412 Forest Hill Fernvale Rd
Chainage: 9.77km
(Lake Clarendon Way intersection)
23 April 2018

CRASH SITE ASSESSMENT
Stage 1 Report

DMS505/00158

Photo 5: Giveaway sign at intersection

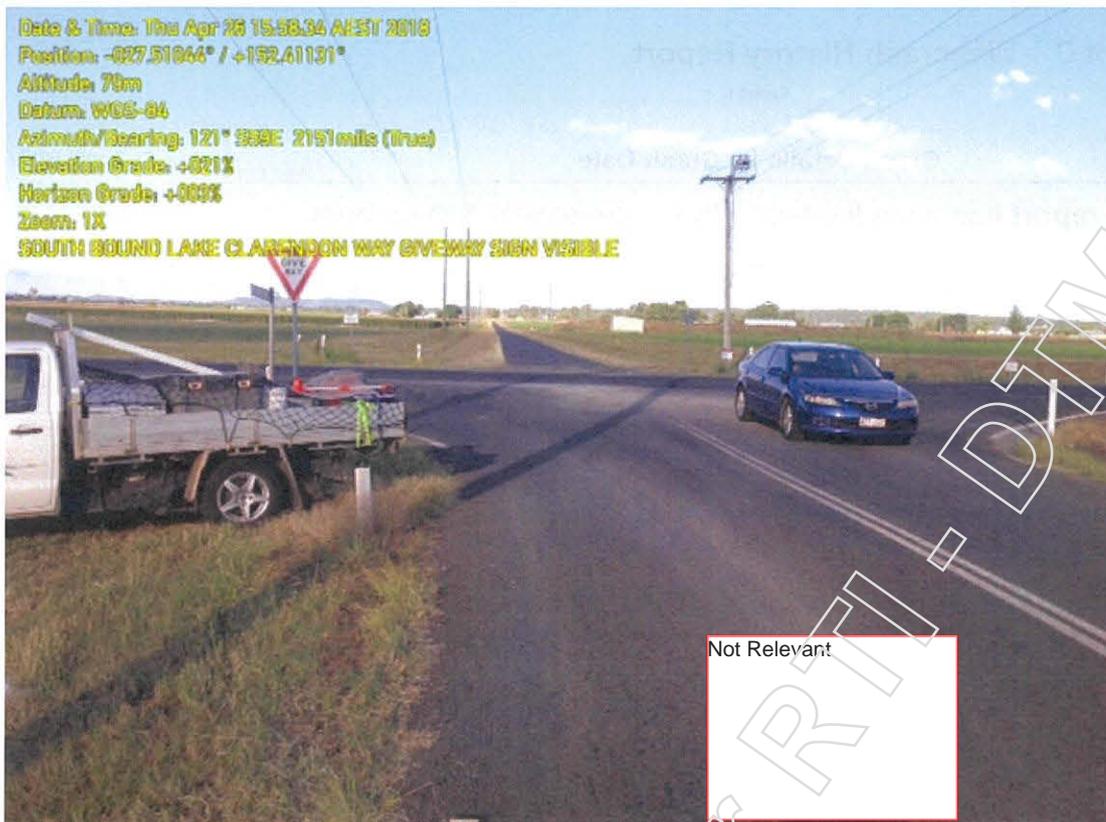
The intersection is controlled by a give way sign. The give way sign is appropriate at this location. Stop signs are used where there is restricted vision in either direction of the major or uncontrolled leg of the intersection (MUTCD Part 2 Cl. 2.5.4). There are no sight obstructions at this intersection.

To improve the conspicuity of the give way sign it could be enhanced with a fluorescent orange border or target board.

To further reinforce the give way sign it could be duplicated in the centre of the road. This would require a splitter island and likely also require associated pavement works to cater for the swept path of heavy vehicles. A reinforced concrete box culvert under Lake Clarendon Way would likely need extending to accommodate additional pavement works.

WALHUBEN ROAD / LAKE CLARENDON WAY INTERSECTION				
SIGNAGE AND LINEMARKING UPGRADES				
GENERAL LAYOUT				
Drawn	M. Holden	ENGINEERING CERTIFICATION (RPEQ)		
Designed	LVRC	ENG. AREA	NAME	SIGNATURE
Checked	T. Moulds	Civil	Karl Zeller	Not Relevant
				NO. DATE
				18371 27/4/18

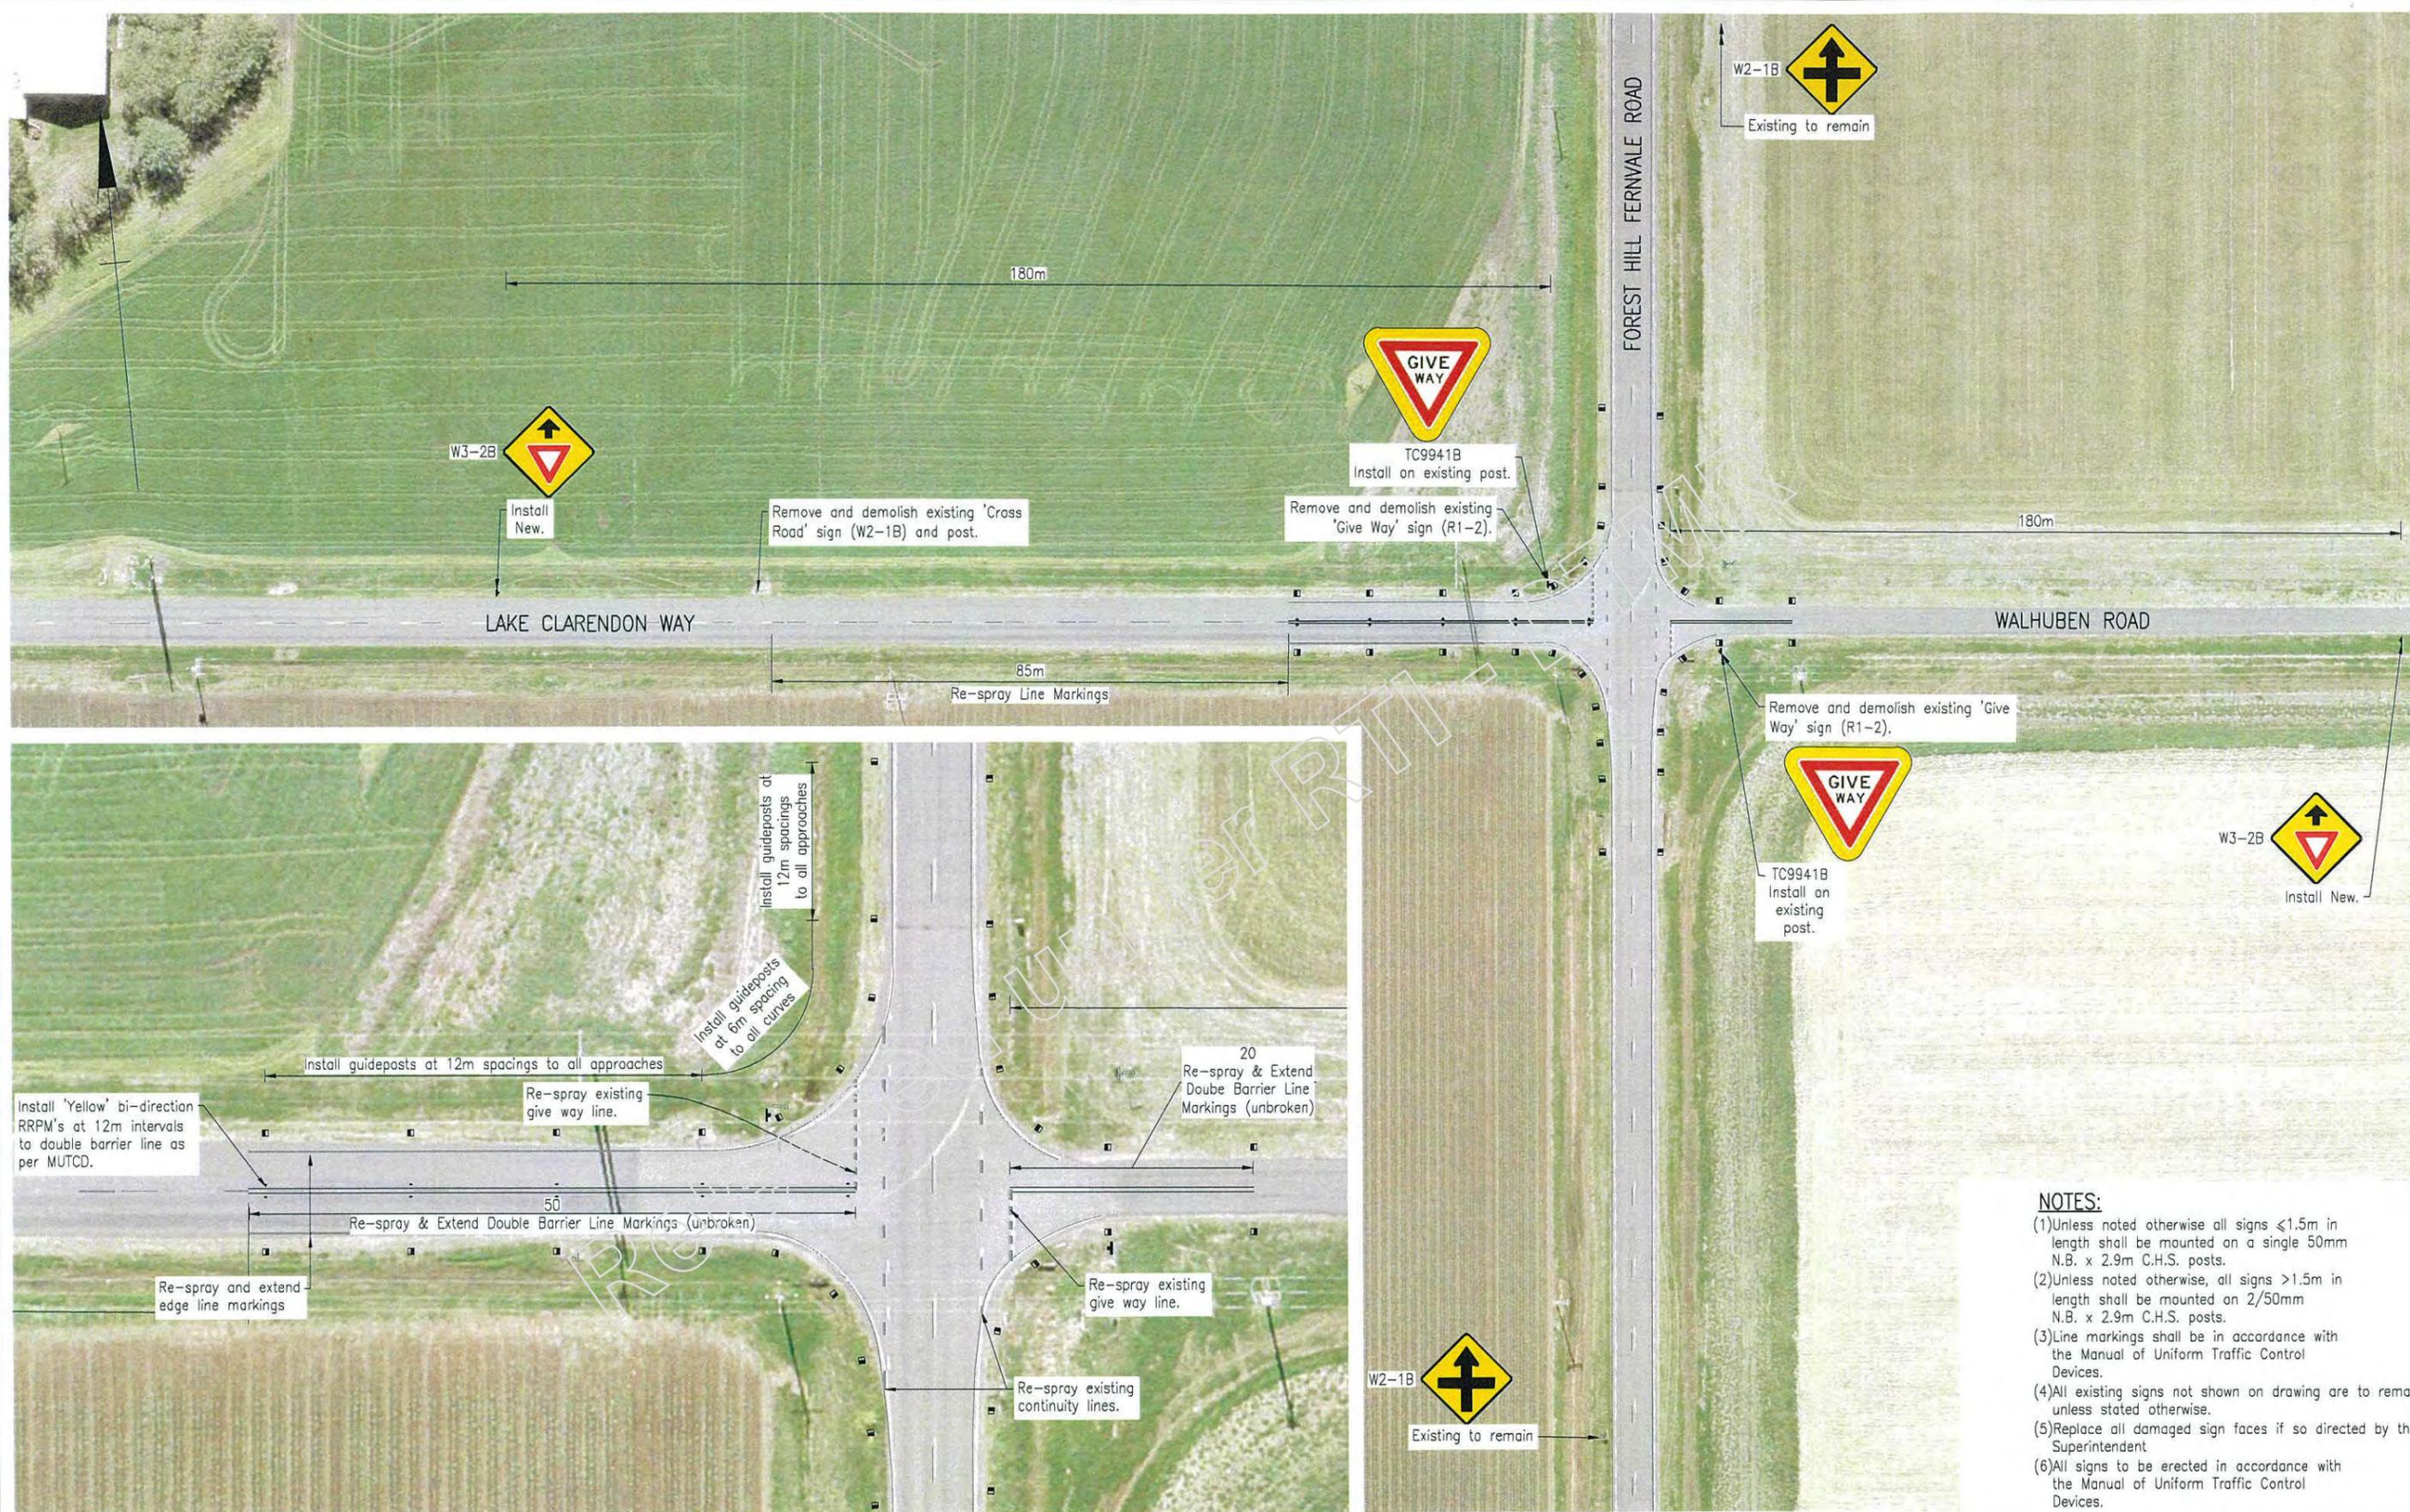
The site had been nominated as a safer road sooner project due to the previous crash history. A project was approved to upgrade the signage and line marking at the intersection. The works were in the design phase at the time of this most recent crash. The proposed works include basic signage and line marking upgrade as mentioned above. A copy of the works is included in Attachment F. The works are expected to be completed in the 2017/18 financial year.

- Upgrade the signage, line marking and delineation at the intersection by implementing the approved Safer Roads Sooner project.
- Installation of a splitter island on Lake Clarendon Way to provide the ability for a give way sign to be duplicated in the median. This option would have a slightly better benefit than the signage and line marking mentioned above. The cost however will be significantly more due to the requirement of pavement and drainage works to accommodate the splitter island resulting in a lower BCR.
- A higher cost solution would be to install a staggered "T" intersection. This option will require land resumptions and likely require relocation of above ground electrical services.

Linemarking and Signs are done. Guide posts and rrpms are pending. These should be complete in the next 2 weeks.

Appendix 2 Concept Design

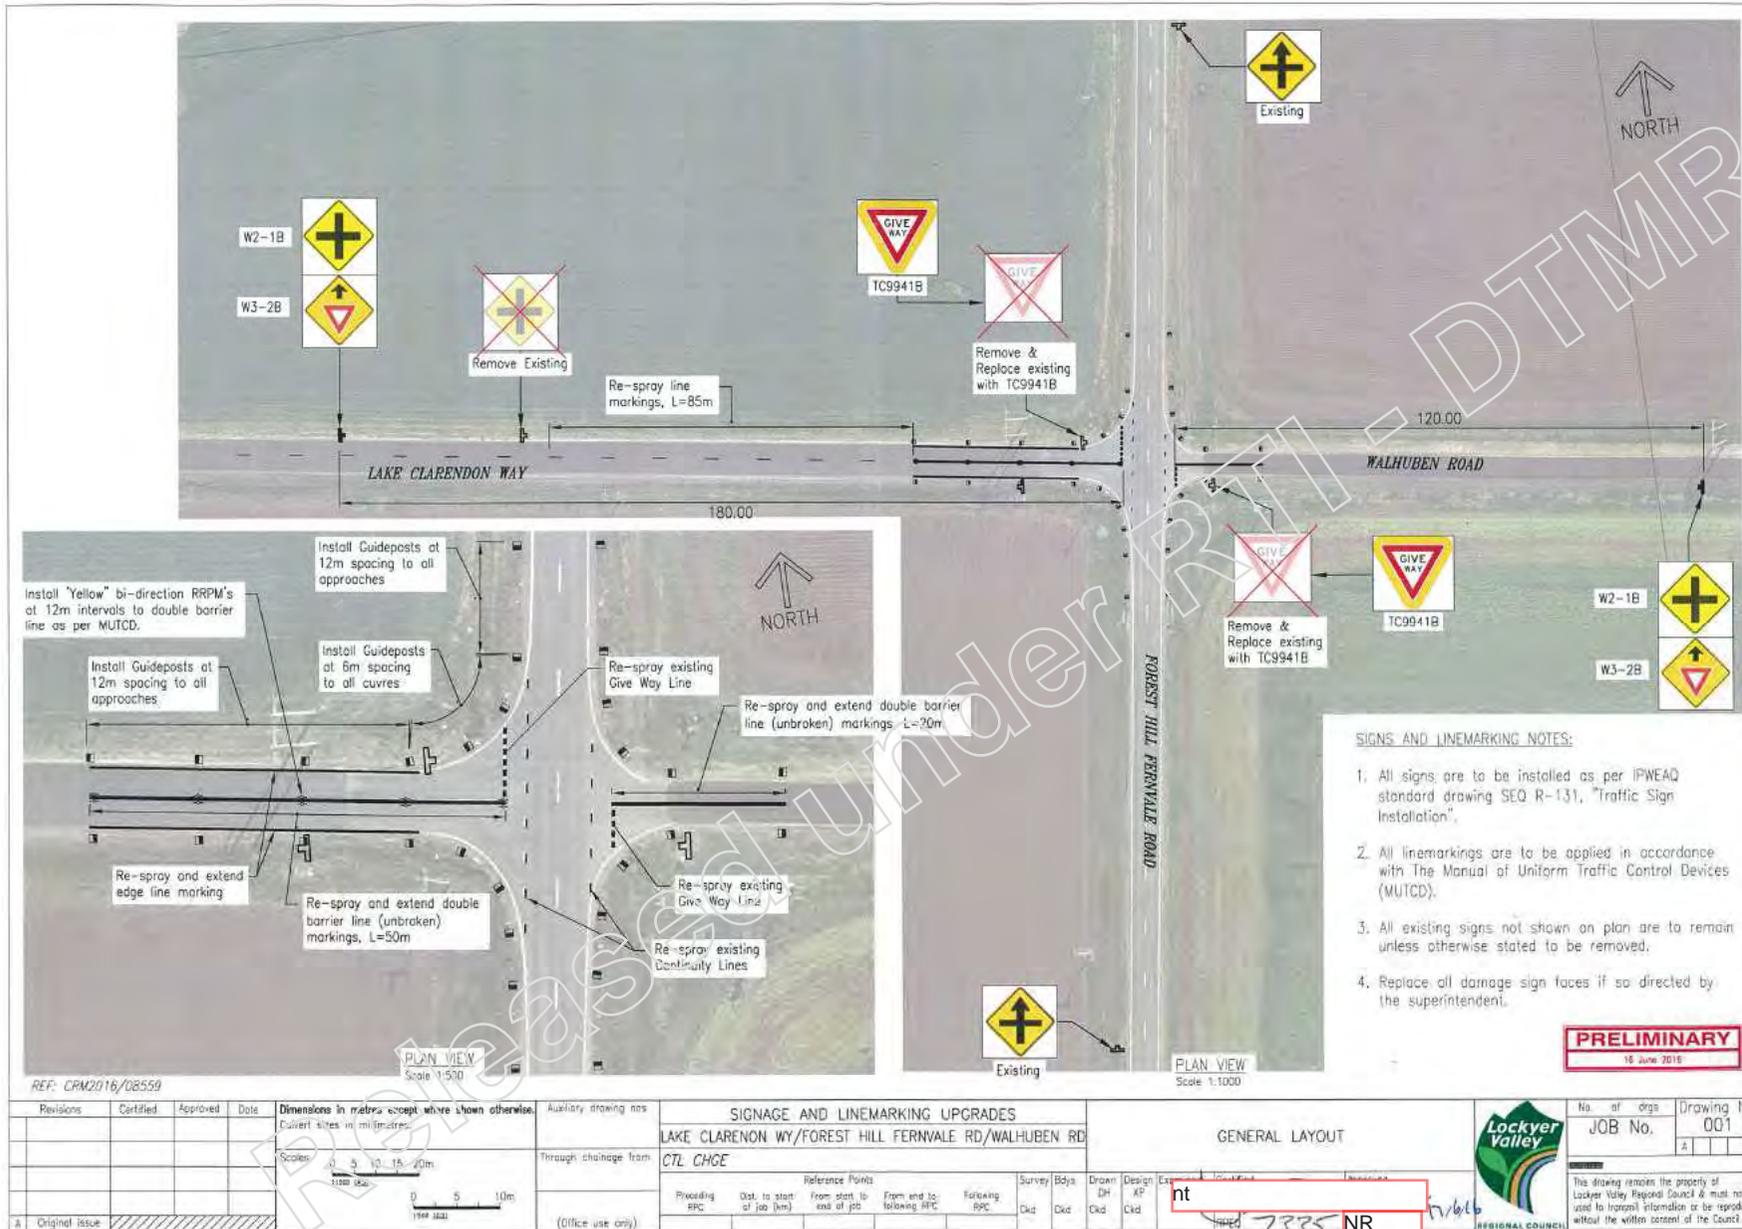
This one was nominated to be a reactive application given that QPS advised that the three crashes were injury crashes at this intersection. The location of give way linemarking – can this be determined/confirmed at detailed design? The plans submitted in support of our nominations were all conceptual only, to be confirmed at detailed design should they be approved for funding.

- I would include existing crashes for all proactive nominations.
- Please ensure Give way line markings at side roads are not too far back.

Figure 12 – Possible Treatment Option

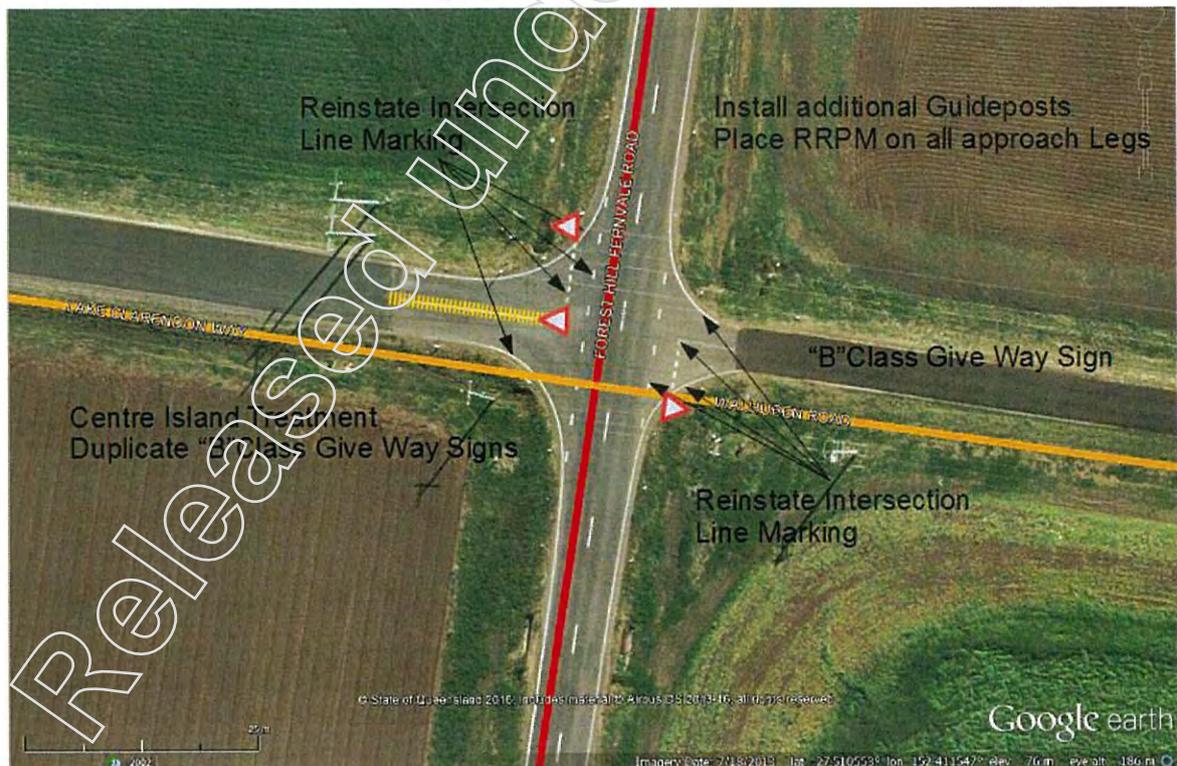
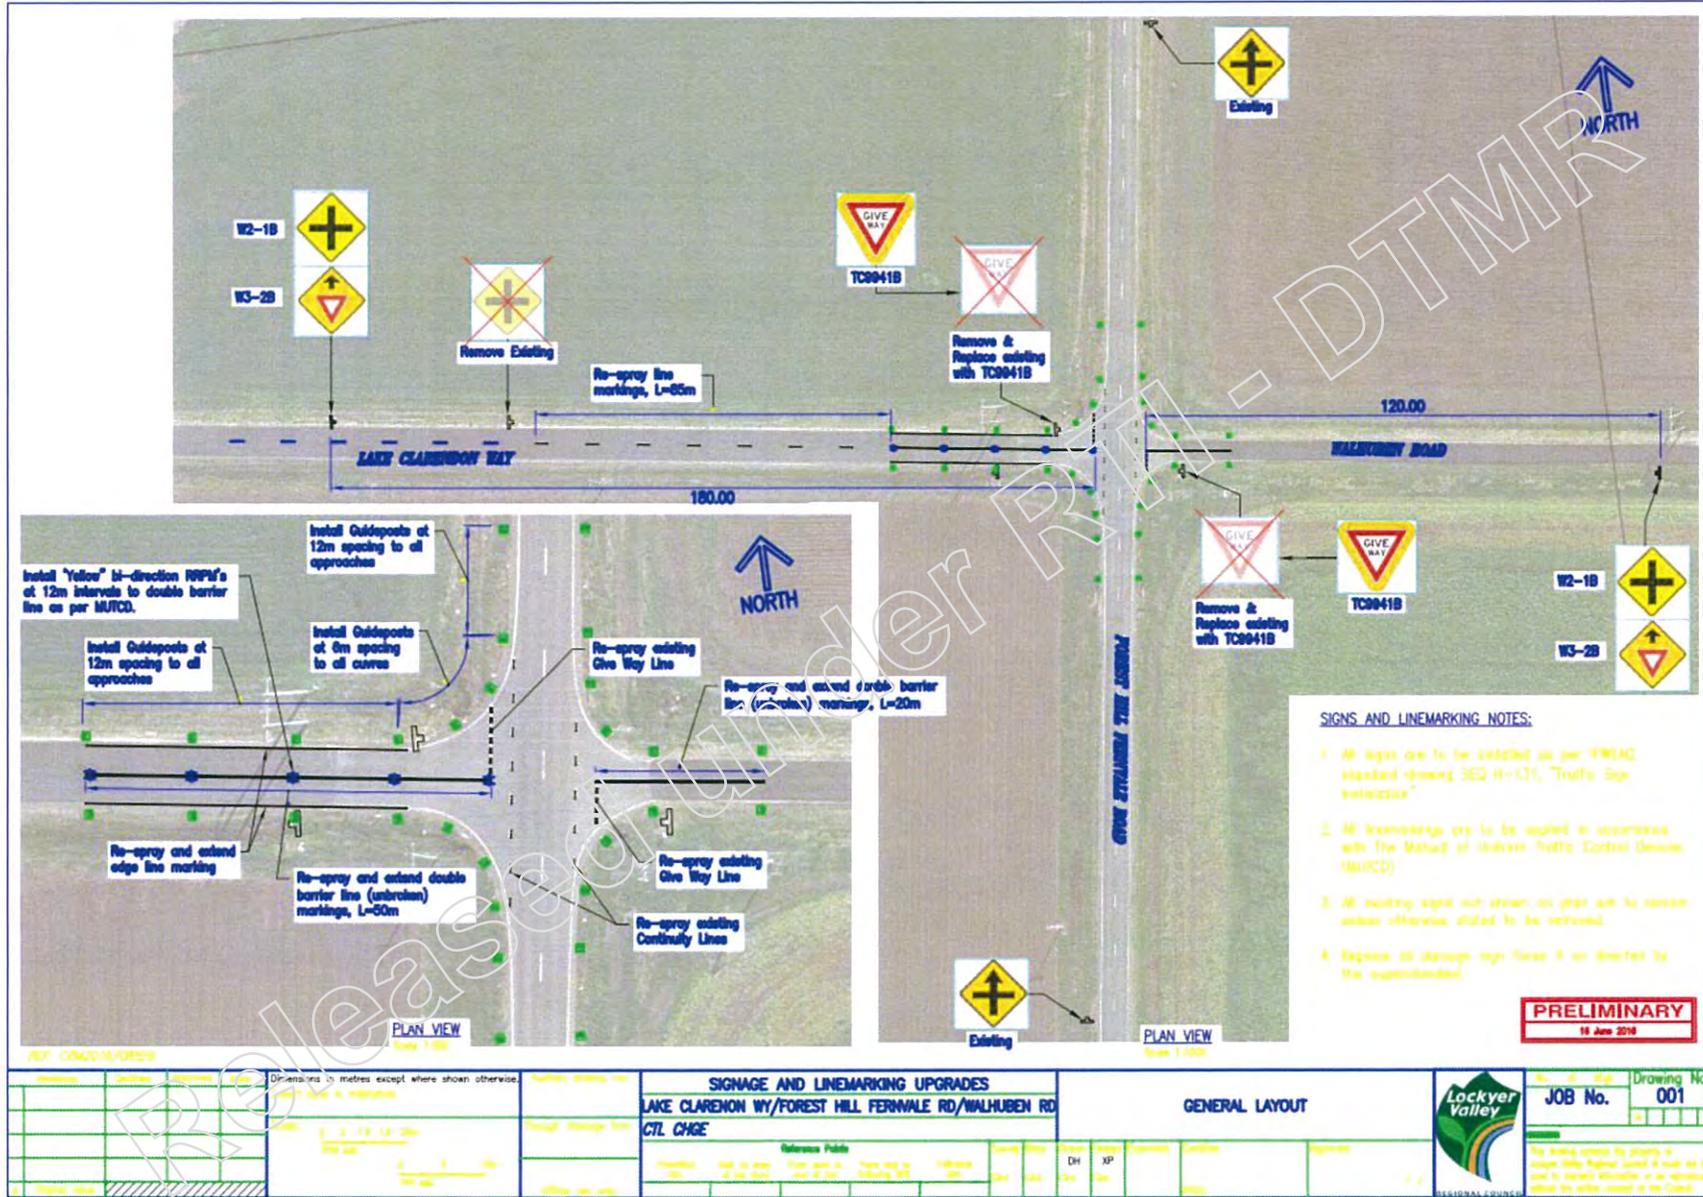
The following diagram is a schematic representation of a possible rectification treatment and if considered feasible would require a detailed site survey and intersection design.
